**SAN ANTONIO WATER SYSTEM
CENTRAL WATER INTEGRATION PIPELINE
MALTSBERGER PUMP STATION IMPROVEMENTS
SAWS Job No. 18-8617
SAWS Solicitation No. CO-00190**

**ADDENDUM No. 4
August 31, 2018**

M-2304

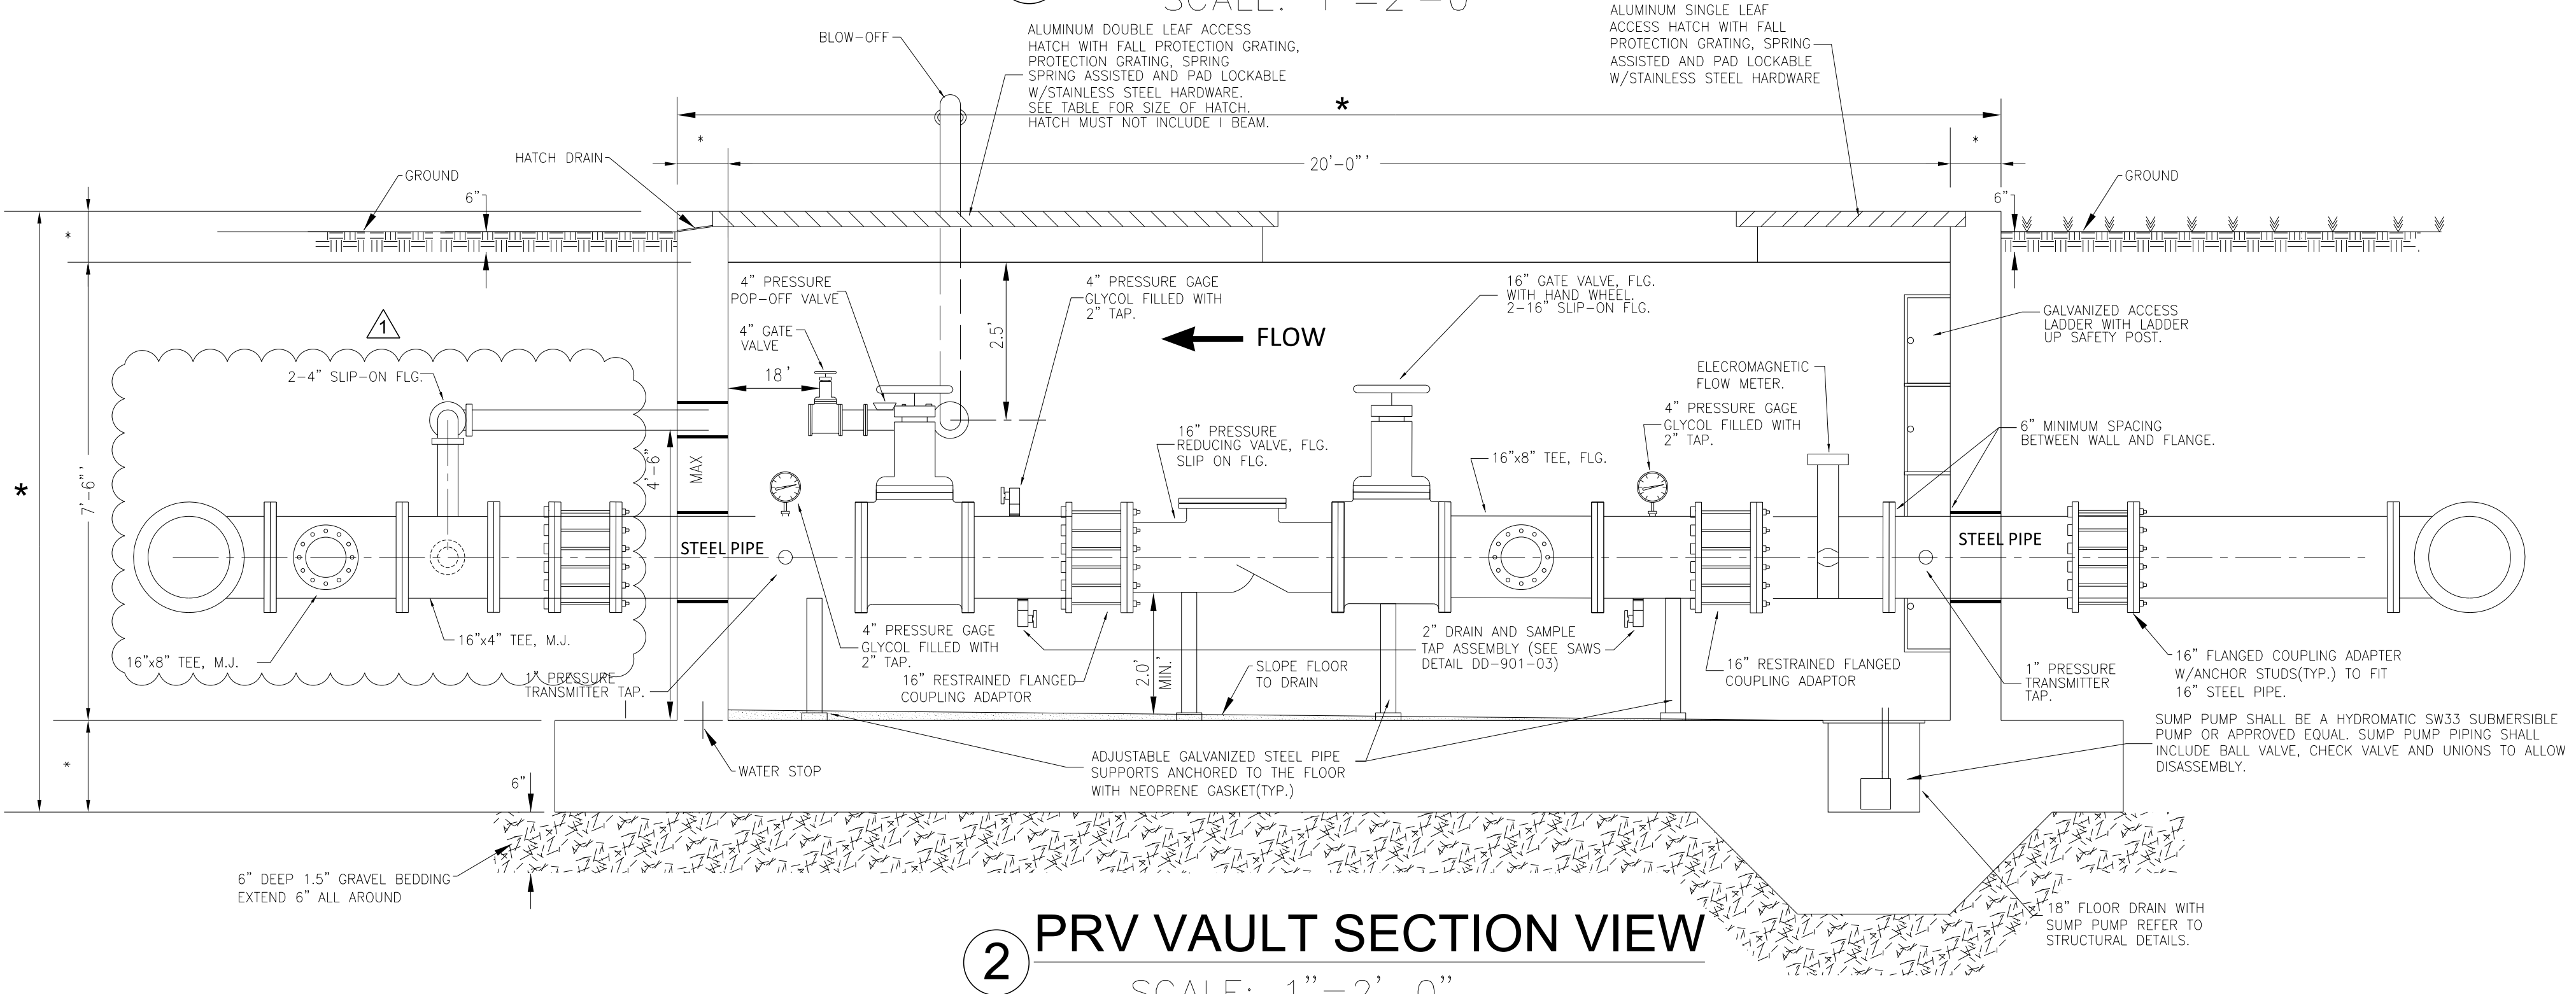
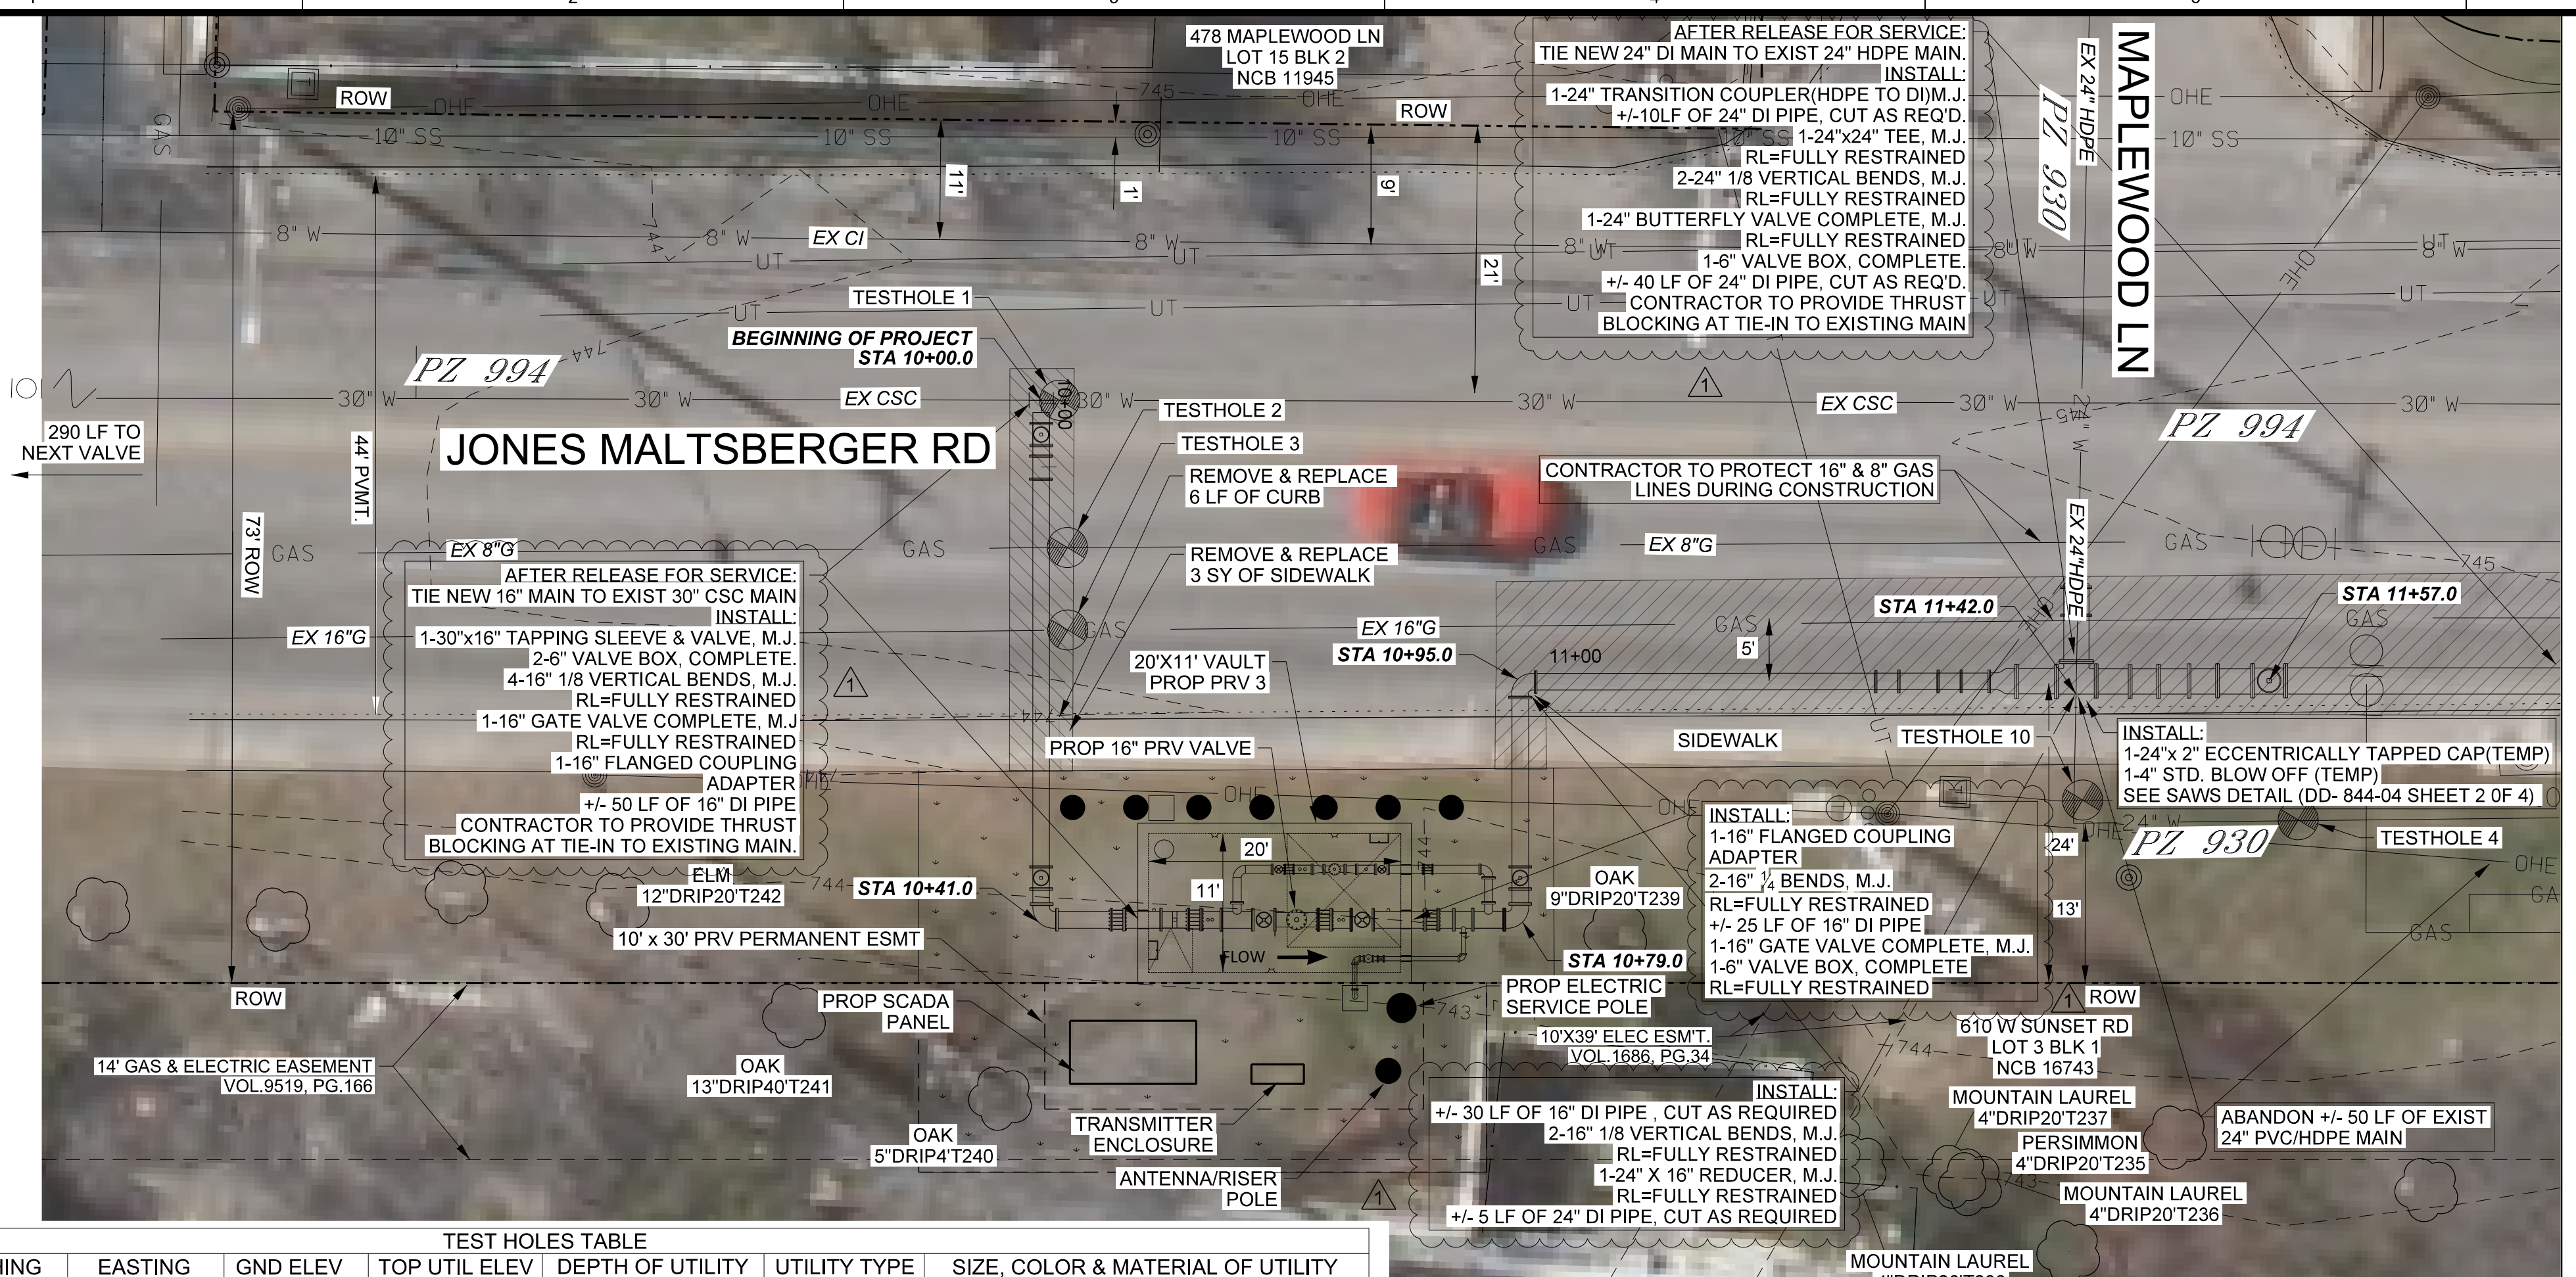
Question No.	Question	Answer
92	Sheet M-2302; "This is not a 90 deg bend (1/4)"	Refer to updated SHEET M-2302 per Addendum No. 4.
93	Sheet M-2304; "Can't put a slip on flange on a gate valve or on DI Pipe".	Refer to updated SHEET M-2304 per Addendum No. 4.
94	Sheet M-2304; "M-2302 shows these to be MJ. Can't be steel and MJ. Where do you want to change from DI to Steel?"	Refer to updated SHEET M-2304 per Addendum No. 4.
95	Sheet M-2306; "These are not 1/4 bends. They are about 30-35 deg. Closest available MJ fitting is 22.5 deg."	Refer to updated SHEET M-2306 per Addendum No. 4.
96	Sheet M-2306; "These are not 1/4 bends. They are about 60 deg. 60 deg MJ fittings are not available."	Refer to updated SHEET M-2306 per Addendum No. 4.
101	On drawing E-2343 are we to supply equipment on this drawing? If so can we can more detail on the lines sizes and etc..	Refer to updated SHEET E-2343 per Addendum No. 4.

E-2338

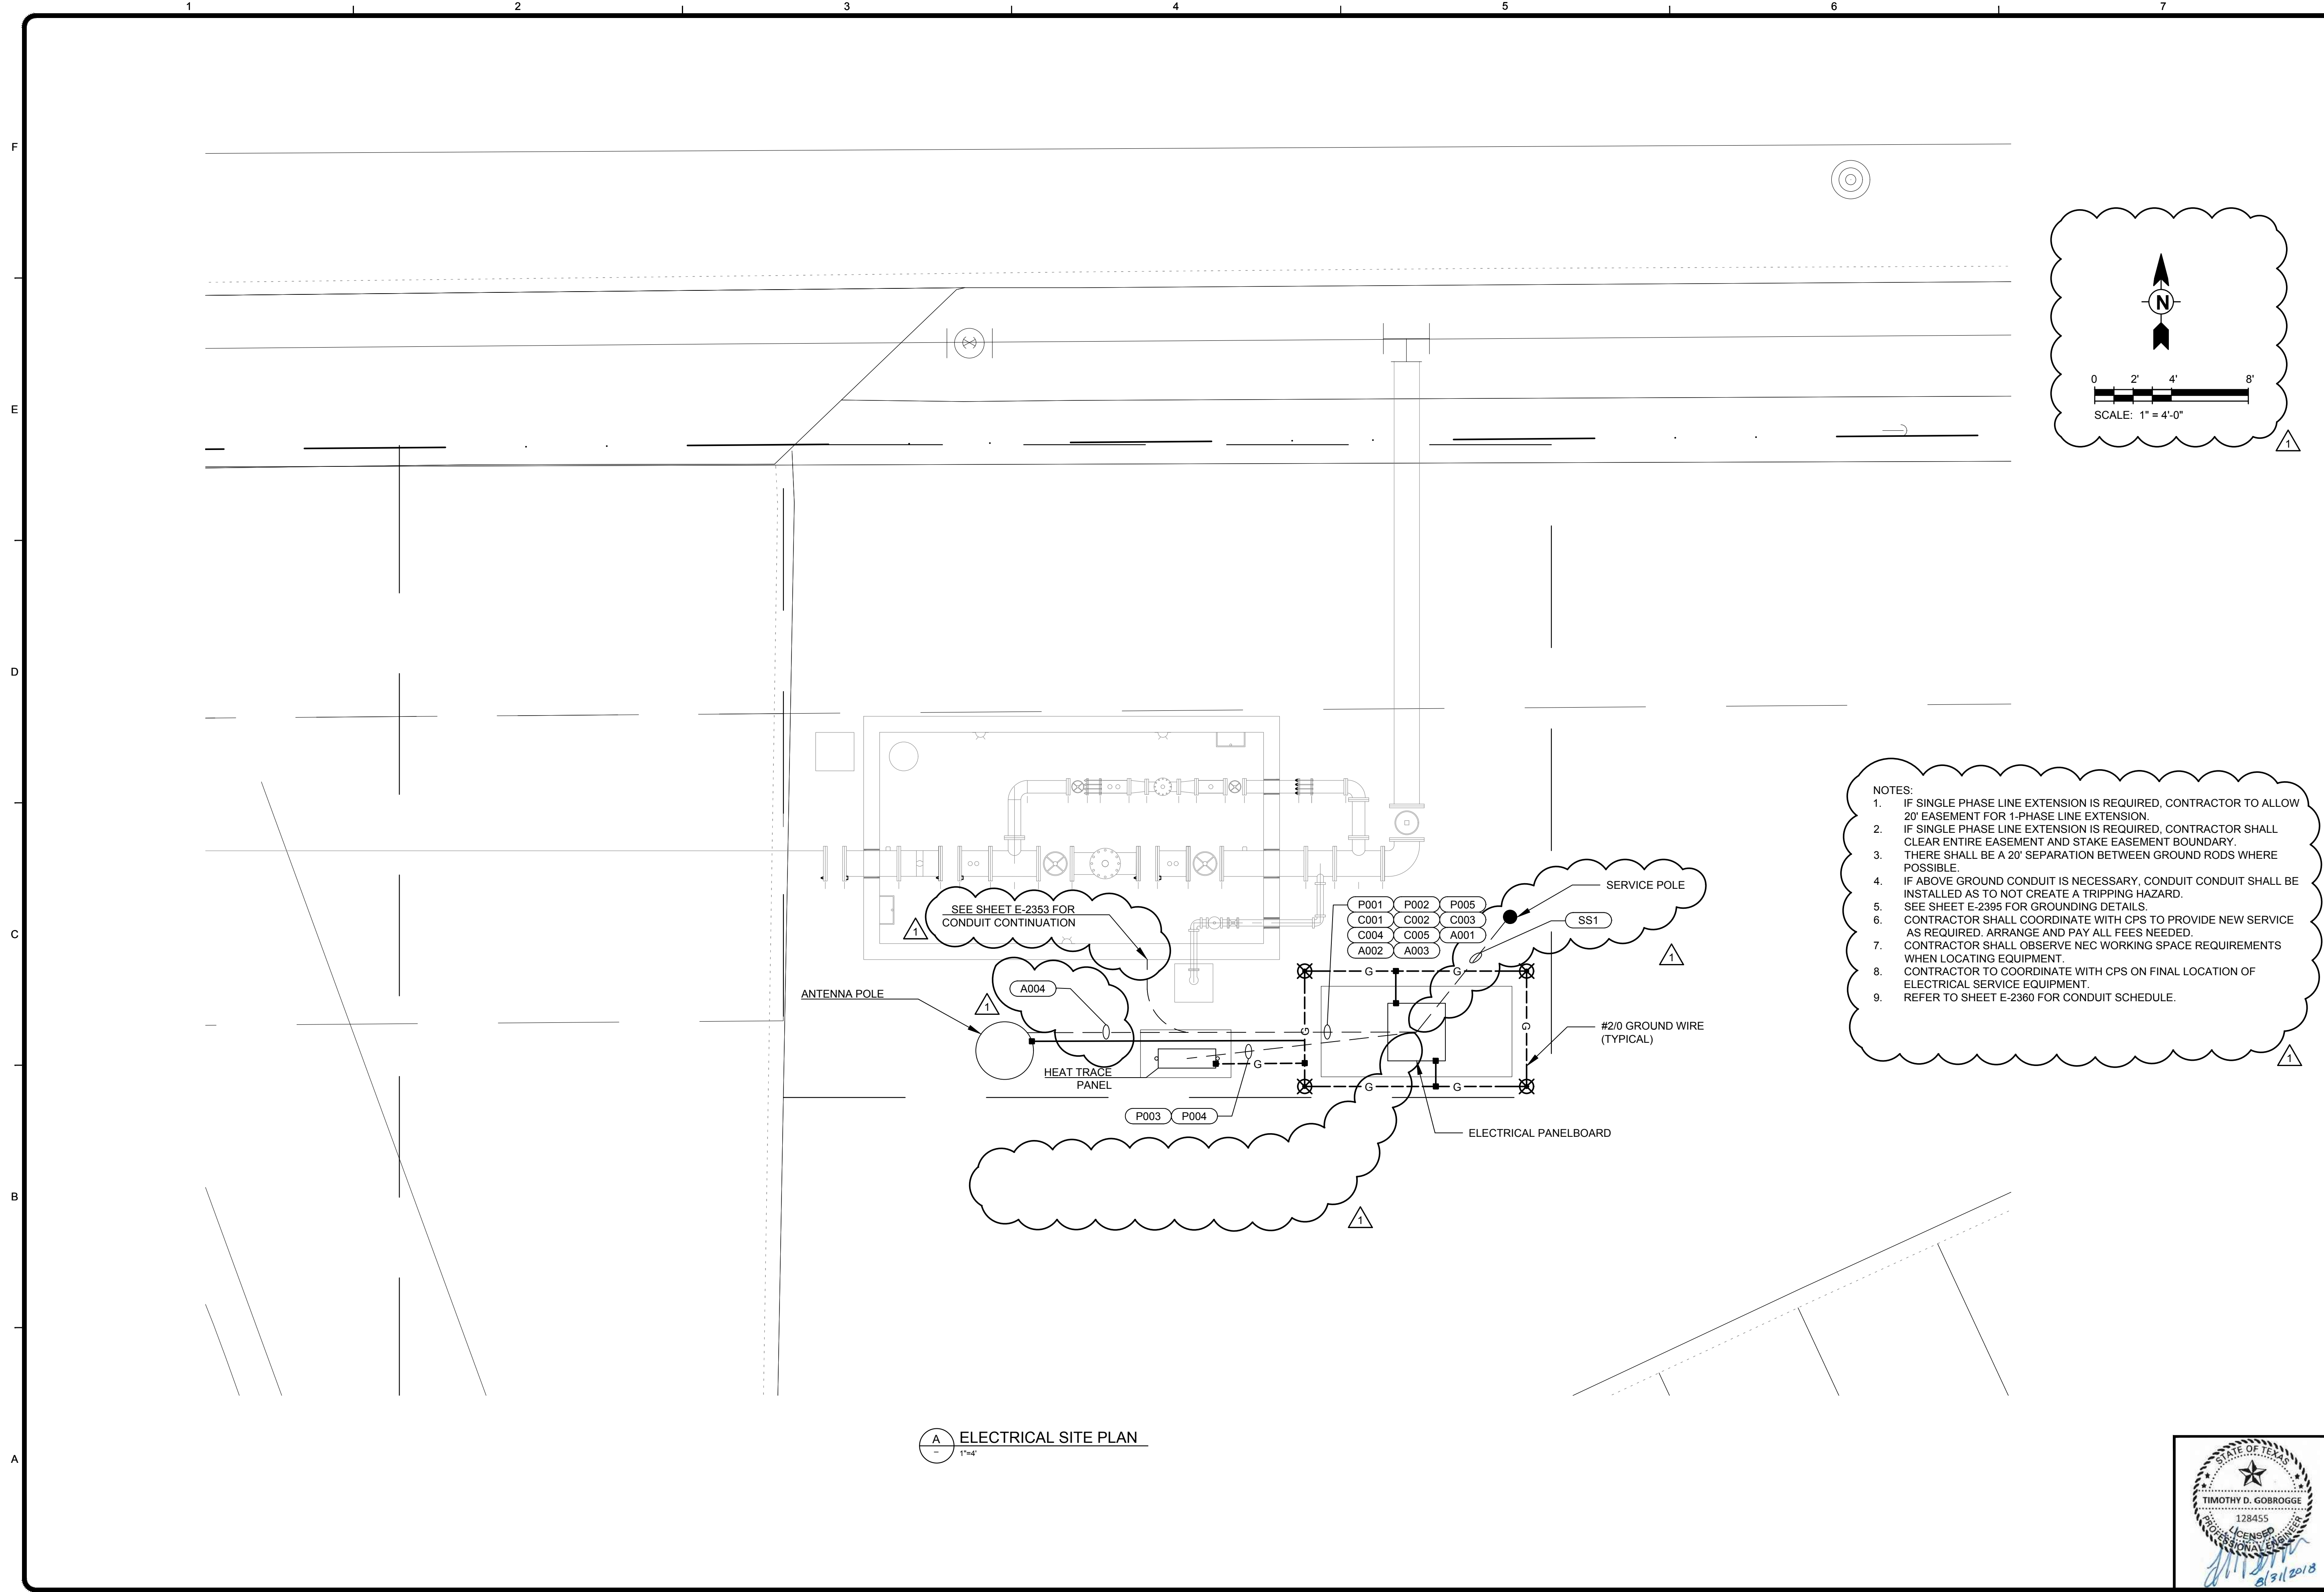
90	Please provide a light fixture schedule for the fixtures shown to be installed in the electrical building at the Maltberger Pump Station	Luminaire schedule has been provided. This is reflected in the changes to SHEET E-2338 per Addendum No. 4.
91	Sheet M-2302; "This is not a 45 deg bend (1/8)"	Refer to updated SHEET M-2302 per Addendum No. 4.
